Tech Bulletin – 2 – Tilt Arms

CRITICAL INSTALLER TECH NOTE 2: For all Dealer/Installers:

Tilt Support Arm - LOWER ATTACHMENT

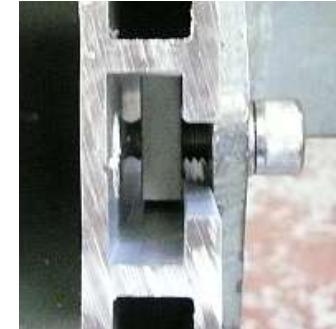
1. Correct use of the tilt arms requires split washers with the M8x20mm bolts on the LOWER attachment points . . . using a ribbed washer is incorrect and allows the end of the bolt to contact the back of the aluminum first, such that the square nut has little if any effect or grip. This can cause the array to tilt or come loose, especially in high winds.

WRONG BOLT M8x16mm
wrong ribbed lock washer
no bolt end showing and bolt does not penetrate square nut

WRONG WASHER M8x20mm
wrong with ribbed lock washer
end of bolt touches rail

CORRECT BOLT M8x20mm
Washer & Correct Split lock washer
end of bolt visible

NOTE: FOR SECURITY
Use 3 Square Nuts
1 x M8x20mm SHCS, Split lock washer and Flat washer
2 x M8x16mm SHCS Split lock washer and Flat washer to prevent “creep” caused by wind buffeting. Torque 36ftlb (48nm)

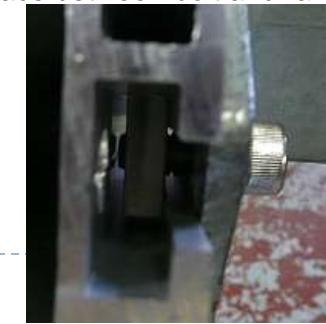
CORRECT BOLT M8x20mm
Space between bolt and rail when torqued

Tilt Support Arm - UPPER ATTACHMENT

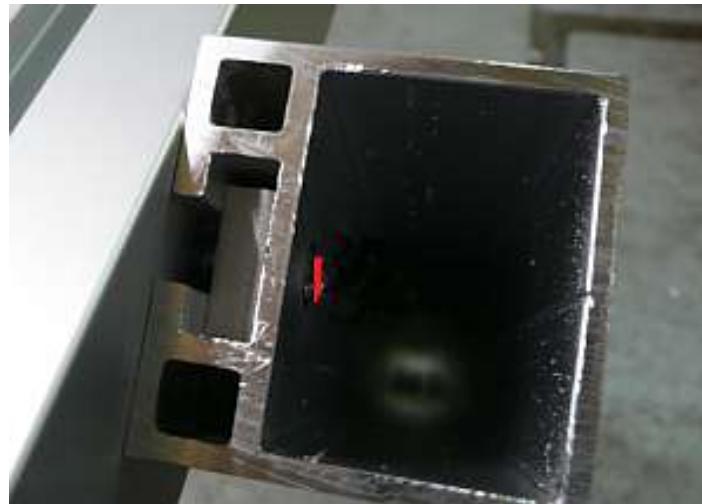
2. The upper attachment bolt M8x30mm must have a flat washer/ribbed washer combination on the bolt before inserting in the rail and a nylock nut on side the rail box. The nylock nut should be snug but not hard tightened against the inner surface of rail since it's purpose is to ensure the M8x30mm bolt cannot fall out if it becomes loose or not properly tightened.

WRONG BOLT M8x24mm

no way to add safety nut

See red mark bolt can fall out

CORRECT BOLT M8x30mm

with nylock safety - un-torqued or loose square nut cannot fall out
